MEMORANDUM

Our Ref: P/2024/0206

P/2024/0206 CHANGE OF USE OF LAND TO CAR PARK

FORMER BRYMBO STEEL WORKS NEW HIGH STREET BRYMBO WREXHAM

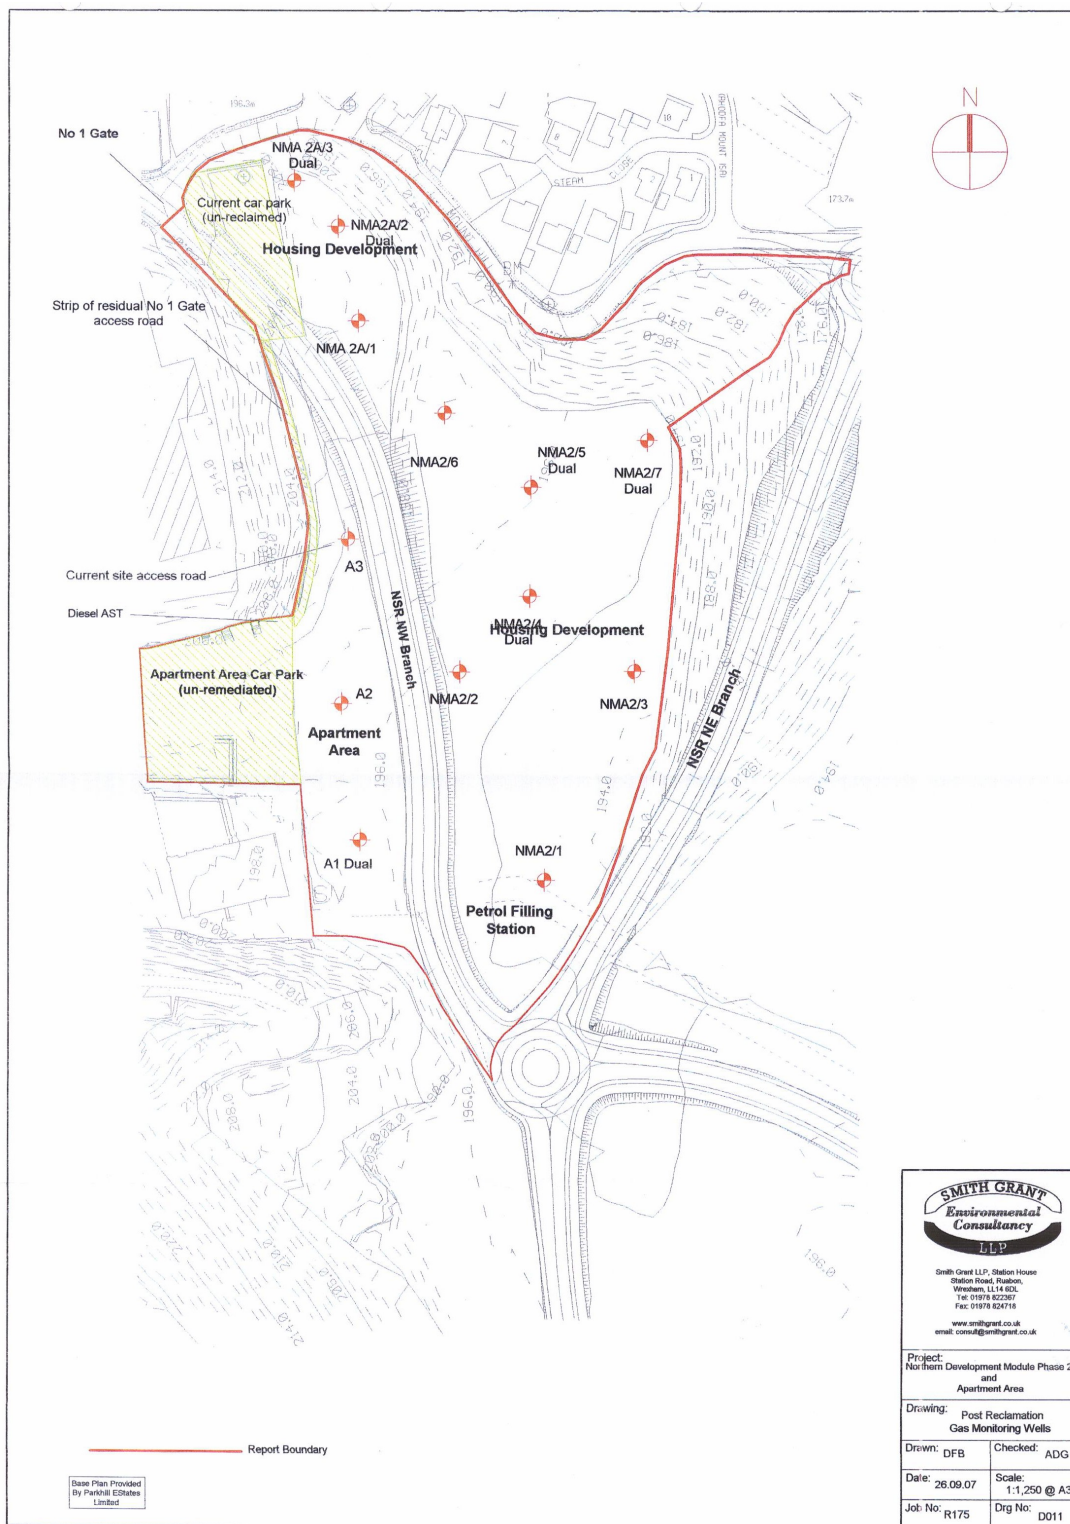
It is noted that the plan below shows the diesel AST (referred to in 11.8) in the proposed development area. Based on this past work I do not consider any further assessment works to be necessary for this application, however due to the matters referred to above in the report extracts, a verification report detailing how any contamination found was assessed and dealt with during the proposed development works is required. Therefore I recommend a site specific condition be applied to the permission if granted.

Site Specific Condition - Verification Report

Due to the potential for residual contamination issues as a result of historical use (former steelworks) of the land, should any made ground or contamination be identified during the works this should be investigated and where required remedial works undertaken. Liaison with the Council's Contaminated Land Officer should take place immediately. The site shall not be occupied/used until a Validation Report has been completed and submitted to and approved in writing by the Local Planning Authority. Reference to concerns detailed in sections 11.5, 11.7 & 11.8 from the *"Former Brymbo Steelworks Northern Development Module Phase 2, Contamination Certification Report, Vol 1: Report & Drawings, For: Brymbo Developments Limited, May 2008, prepared by Smith Grant LLP"* should be included within the validation report.
